March 17, 2015

**RE: Lot 15, Block 2, Unit 3, Tract 3, Eagle Rock Avenue
Grading and Drainage Plan
Engineer's Stamp Date 2-22-2015 (File: C20-D056B)**

**LOT 15, BLOCK 2, UNIT3, TRACT 3, NAA
GRADING AND DRAINAGE PLAN**

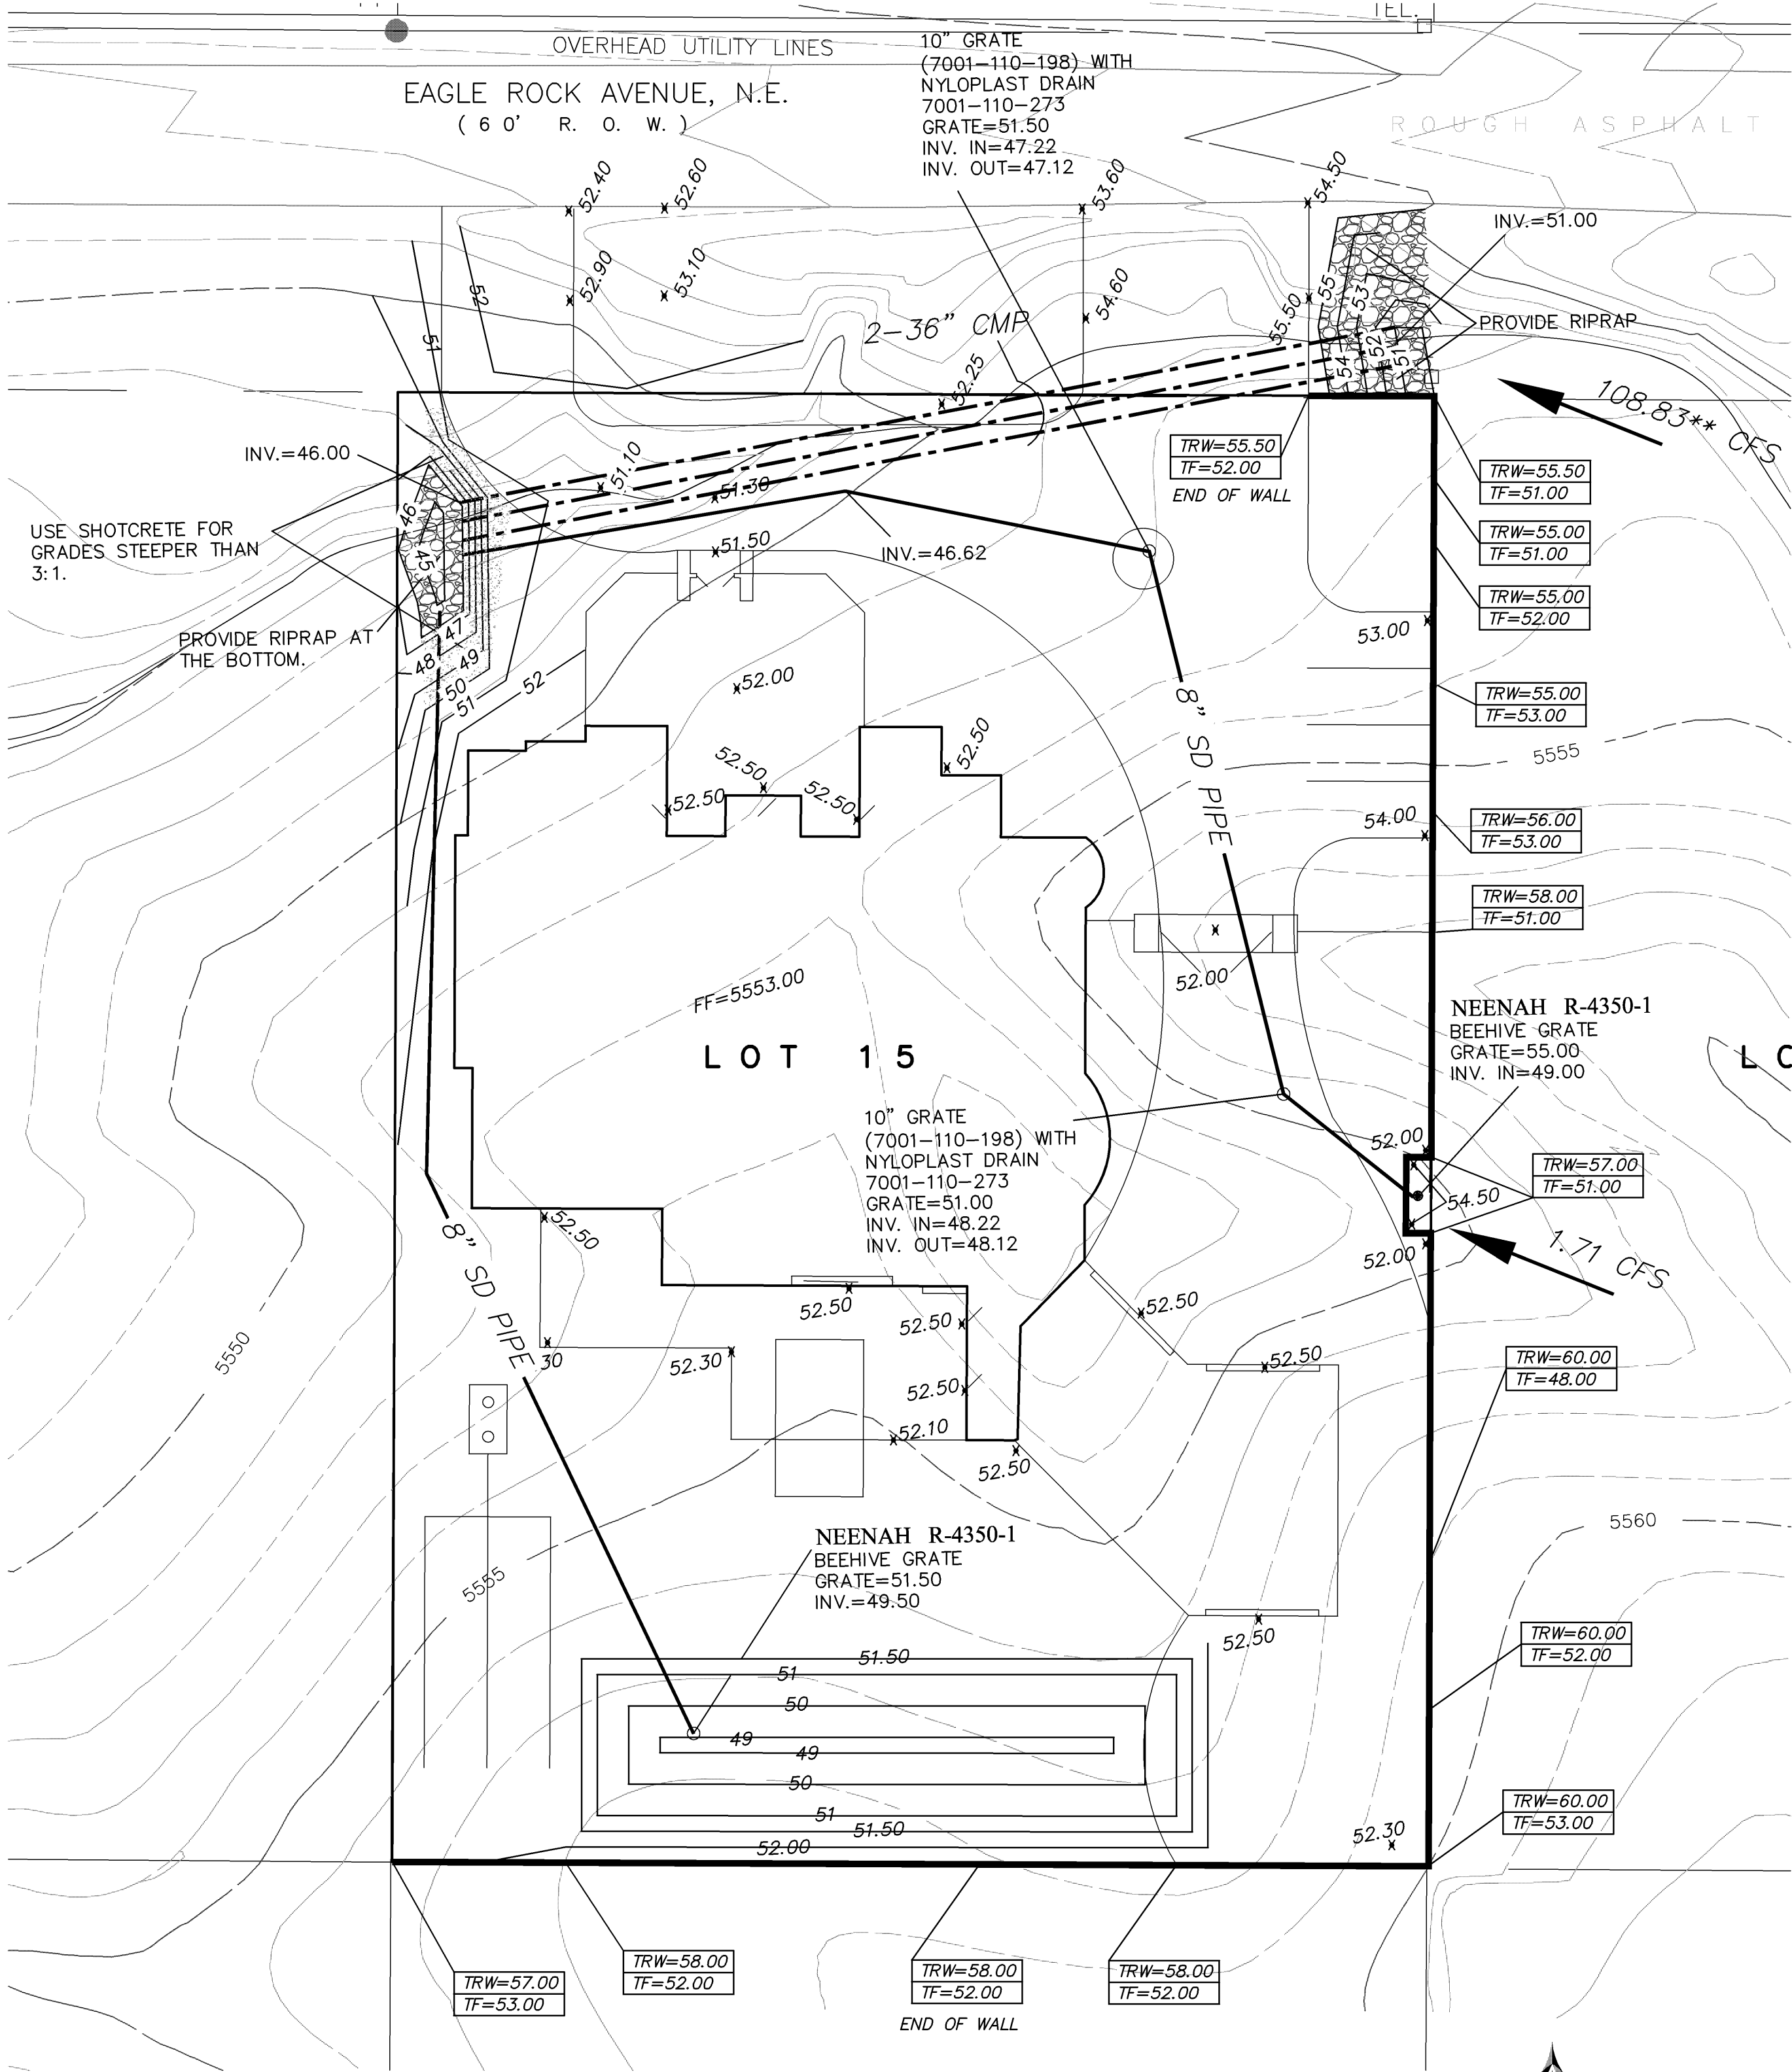
- 1) Provide a survey benchmark and existing spot elevations along the entire site perimeter.
- 2) Label the first flush volumes on the plan view. Show the roof drain locations. If part of the roof is draining to the north, locate some of this retention for the first flush immediately to the north of the proposed building, and label the volume of retention at this location.

- 3) How do the retaining wall heights match existing contour elevations? In addition to providing the top of retaining wall, provide the bottom of wall elevations in lieu of the top of footing elevations. (The elevations for the wall labeled along the southeast corner of the site look incorrect.)

- 4) Provide new contours tie-ins to existing contours at the site boundaries. Existing contours do not appear to represent improvements on Lot 18 to the south. On Lot 18, there is already an existing wall along the boundary, and the proposed wall construction conflicts with this. Also, show boundary line for subject property according to the legend.

- 5) Show calculations for the 1.71 cfs of off-site flow discharged to the site from the east. How is the flow getting to each of the on-site inlets? (The listed beehive grate elevations appear to be too high relative to the surrounding areas.) Provide more

- proposed contours. Include discussion of off-site flows within the "Proposed Conditions" write-up, and also include a very brief description of Basin 11.0 from the NAA Report, especially since it is a huge contributor of off-site flow.

- 6) On the downstream end of the pipe where the riprap is shown, provide calculations for determination of both riprap dimensioning and sizing. Specifically for the sizing, provide a "d50" of 9 inches or else provide a computation for determination of sizing. For the riprap dimensioning, there is a concern that there is not as long of a riprap section downstream of the two 36" pipes to handle the amount and the velocity of flow.

- Based upon these calculations, show the size and depth of riprap that is placed at the downstream and upstream ends of the pipe. If a longer section of riprap is required based upon these calculations, shorten the two 36-inch pipes to make more room for the riprap.

- 7) There is concern about scour where the shotcrete meets the riprap. Either provide a scour wall that extends a minimum of two feet below grade, or provide computations for the required depth of the scour wall.

- 8) Label the slope of the two 36" pipes on the plan view. If these are CMPs, call out the gauge of the pipes.
- 9) Show the proposed driveway location for the site and the proposed grades. Show adequate pipe cover at the point where the proposed driveway crosses over the 2-36" pipes.

- 10) Show proposed pipe run slopes for the proposed 8" pipe and the 100-year flow each individual pipe run is conveying. Provide capacity calculations for each of the individual pipe runs.

- 11) To reduce on-site flow from discharging to the site immediately to the west, provide an inlet for the 8" storm drain system to capture the flow from the southwest corner of the site.

- 12) Place headwall at the inlet location for the two 36" pipes.
- 13) The property owner is unable to directly access the beehive grate that is proposed on the east side of the site on the other side of the retaining wall. In lieu of this configuration for collection of off-site flows, it is recommended to collect the 1.71 cfs on the opposite side of the wall. Grade the site to make sure the flow gets into the grate, and ensure that there is flow away from proposed building.

- 14) In order to make the backyard area more usable, it is permissible to slightly raise the bottom grade of the backyard detention pond.
